UNITED STATES PATENT AND TRADEMARK OFFICE

APPLICATION NO.	FILING DATE	FIRST NAMED INVENTOR	ATTORNEY DOCKET NO.	CONFIRMATION NO.
09/585,472	06/02/2000	Michiaki Sakamoto	157330/99	6609

Office Action Summary	Application No. 09/585,472	Applicant(s) SAKAMOTO, MICHIAKI	
	Examiner Timothy L. Rude	Art Unit 2883

FIG. 6(c)

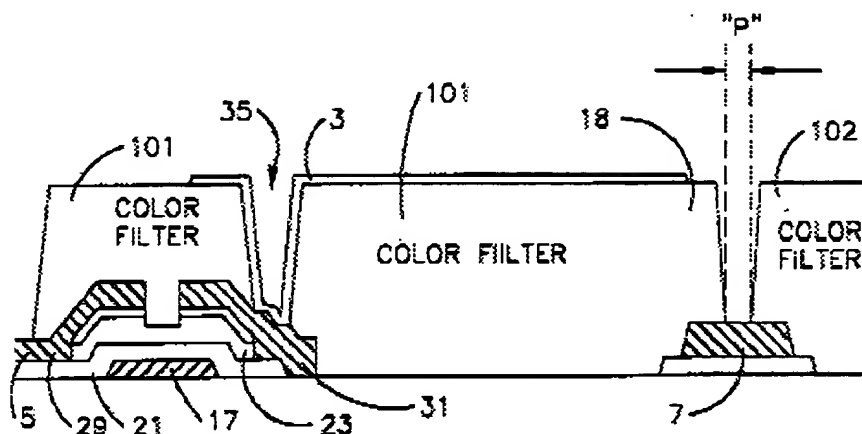
As to claim 1, Zhong discloses (entire patent, especially Figures 6(a)-6(c) and 11) an active matrix liquid crystal display device (col. 8, line 22 through col. 11, line 28), comprising: a first substrate, 19, and a second substrate, 51, at least one of said first substrate and said second substrate being transparent; a plurality of scanning lines, 7, formed on said first substrate; a plurality of signal lines, 5, formed on said first substrate crossing said scanning lines in a matrix manner a plurality of thin film transistors, each said thin film transistor respectively formed at an intersection of said scanning lines and said signal lines, each said thin film transistor comprising: a gate electrode, 17, formed on said first substrate; a gate insulation layer, 21, formed on said gate electrode; a semiconductor layer, 23, formed on said gate insulation layer; a drain electrode, 29, formed on a first portion of said semiconductor layer and a first portion of said gate insulation layer; and a source electrode, 31, formed on a second portion of said

semiconductor layer and a second portion of said gate insulation layer; at least one color filter, 101, formed on said first substrate; a plurality of pixel electrodes, 3, each respectively connected to one of said thin film transistors through a contact hole, 35, and each respectively formed on one of said at least one color filter; a counter electrode, 49, formed on said second substrate; and a liquid crystal layer, 45, between said first substrate and said second substrate, said liquid crystal layer being driven by electric fields between said pixel electrodes and said counter electrode to thereby make a display, wherein said color filter is formed directly on said first substrate (per Figure 6(c)) in substantially all of a light transmission region within a pixel area surrounded by said scanning lines and said signal lines, providing an efficient high aperture display [Abstract, Applicant's a thickness of said color film forming said color filter being a preselected first thickness that provides a sufficient chromaticity for said color filter; please note that the display of Zhong has a preselected first thickness that does provide the color display of Zhong with efficient high aperture display performance, per Zhong], and said color film comprises a stack of layers [stacked on top of transistor layers] that reduces a thickness of material of said color filter near said contact hole such that said second thickness is processed successfully to form a functional contact hole [Applicant's thickness chosen to permit a photo-crosslinkage to occur in an entire thickness of said second thickness of said color filter material during an exposure processing of said contact hole] (per Figure 6(c)).

Zhong teaches the use of a color filter, 101, consisting of a photosensitive organic film (resist) with a color pigment or dye (col. 16, lines 43-46) that is substantially flat on the top surface (as illustrated in Figure 6c), therefore a difference in level generated on a surface of the organic film being not more than $0.3\ \mu\text{m}$ as a results effective variable for reducing line-pixel capacitances (Abstract) (MPEP 2144.05 II B).

FIG. 3

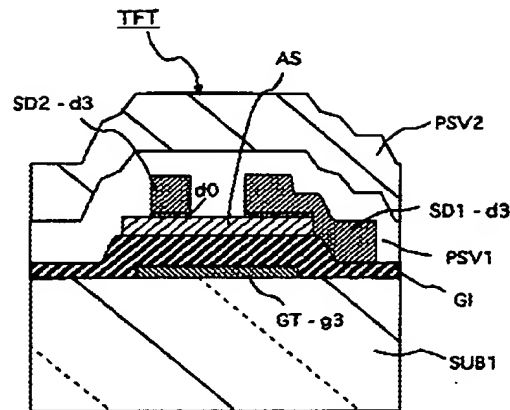
Ohta teaches the use of a passivation film exclusively over and in direct physical contact with the TFT portions to protect a back channel portion of the TFT and thereby stabilize a threshold voltage, V_{th} (col. 8, lines 34-67) without warping of the substrate caused by the stress of said passivation layer. Please note that modification of the device of Zhong with the passivation film of Ohta would result in said passivation film and said color film form a stack of layers that reduces a thickness of material of said color filter near said contact hole such that a portion of said passivation film remains in place adjacent to said contact hole.

Ohta is evidence that ordinary workers in the art of liquid crystals would find the reason, suggestion, or motivation to add a passivation film exclusively over and in direct physical contact with the TFT portions wherein said passivation film and a color film form a stack of layers that reduces a thickness of material of the color filter near said contact hole such that a portion of said passivation film remains in place adjacent to said contact hole to protect a back channel portion of the TFT and thereby stabilize a threshold voltage, V_{th} , without warping of the substrate caused by the stress of said passivation layer.
